2.0 PROJECT DESCRIPTION COMMENTS AND RESPONSES

Figure 2-9: Concept Elevations - 3 Multi Family Buildings
 Buena Vista Teutonia PUR
 City of Yonkers, Westchester County, New York
 Source: The Lessard Architectural Group, P.C.
 BKSK Architects, LLP
 Drawing Date: 01/12/10

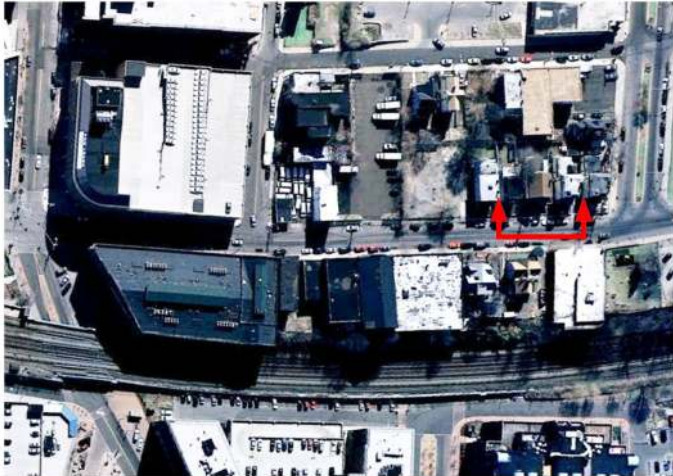
Comment 2-19 (Letter 15, January 24, 2011, Syrette Dym, AICP, VHB - City Planning Consultant): Figure 2-9 does not depict the buildings on the east side of Buena Vista Avenue. Please provide the correct exhibit.

Comment 2-58 (Letter 18, April 22, 2011, Yonkers Dept. of Planning & Development): Project Architectural Design Page 2-13. Figure 9 is a repeat of figure 7 showing the rear of the project on the west side of BVA.

Response 2-19: Figure 2-9 is attached. It was inadvertently omitted from the DEIS.

Response 2-58: *Comment noted. See Figure 2-9 appended to the FEIS.*
